**ADDENDUM NO. 1**  
**2025 ASPHALT OVERLAY PROJECT**  
**PROJECT #12525**

**ATTENTION ALL BIDDERS AND PLANHOLDERS:** You are hereby notified that the Bid and Contract Documents are amended as follows:

2025 ASPHALT OVERLAY

SHT. 63

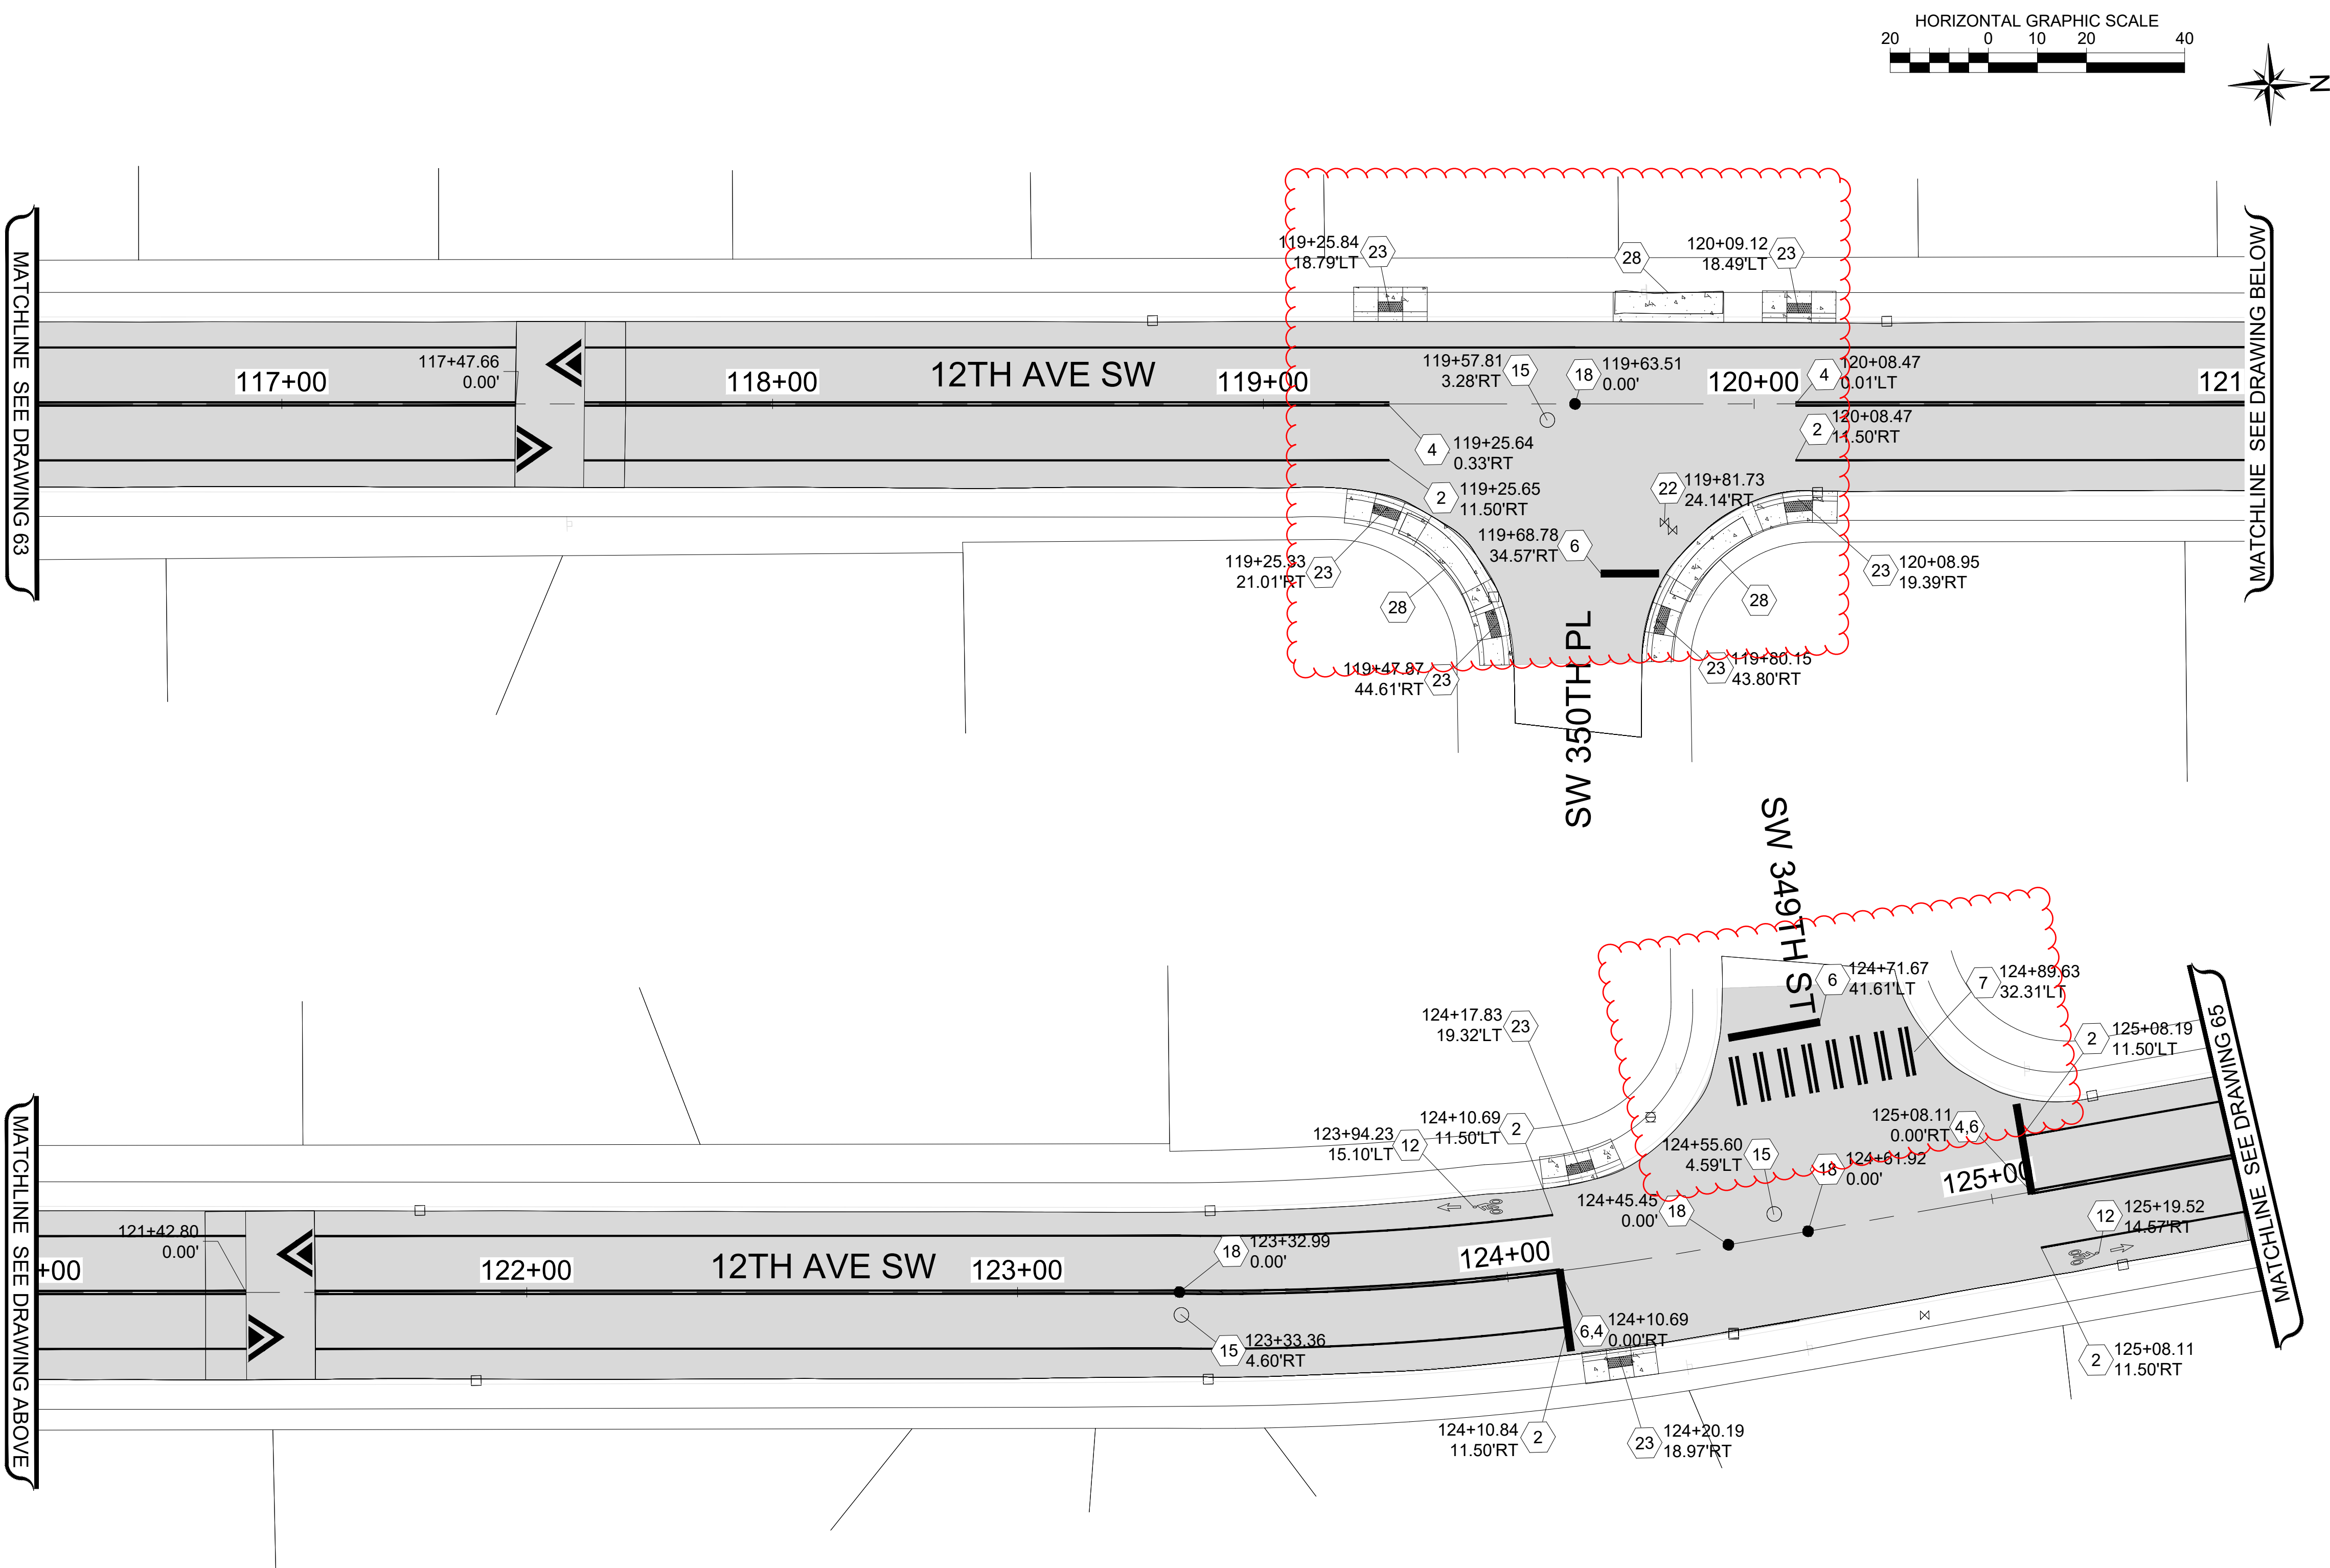
### **(4) Sheets 63-66 of 125 Plan Set:**

- Added Cement Conc Sidewalk Callouts
